**SUSQUEHANNA STEAM ELECTRIC STATION
PROPOSED LICENSE AMENDMENTS TO REVISE
DIESEL GENERATOR SURVEILLANCE
REQUIREMENTS WITH NEW STEADY STATE
VOLTAGE AND FREQUENCY LIMITS
PLA-7471**

**Docket Nos. 50-387
and 50-388**

Susquehanna Nuclear, LLC Evaluation of Proposed Amendment

Subject: Proposed License Amendments to Revise Diesel Generator Surveillance Requirements with new Steady State Voltage and Frequency Limits

Figure 5

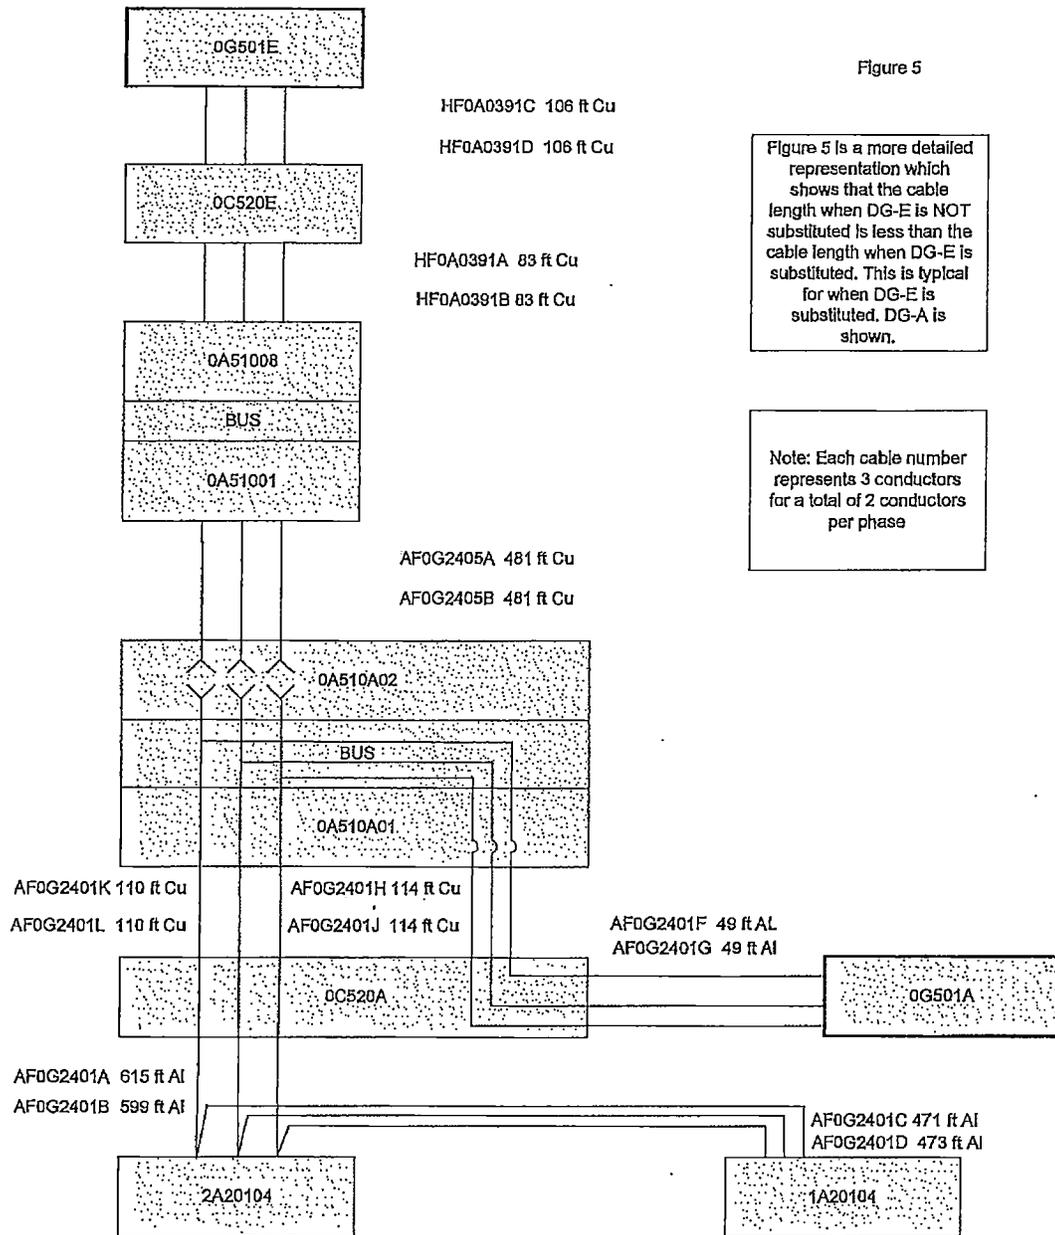
Referring to Figure 5, when DG-E is not substituted, the cable lengths shown from DG-E to 0A510A02 are replaced by DG-A cables AF0G2401F and G (F10's) at 49 ft each and AF0G2401 J and H at 114 ft each (H01's). These cables add up to less impedance compared to using the cables when DG-E is substituted. A review of Table 1 for the analogous cables for DG-B, C, and D shows that in all cases, as expected, the lengths when DG-E is substituted are greater than when DG-E is not substituted, and the corresponding circuit impedance is greater with DG-E substituted.

Figure 5 is a more detailed representation which shows that the cable length when DG-E is NOT substituted is less than the cable length when DG-E is substituted. This is typical for when DG-E is substituted. DG-A is shown.
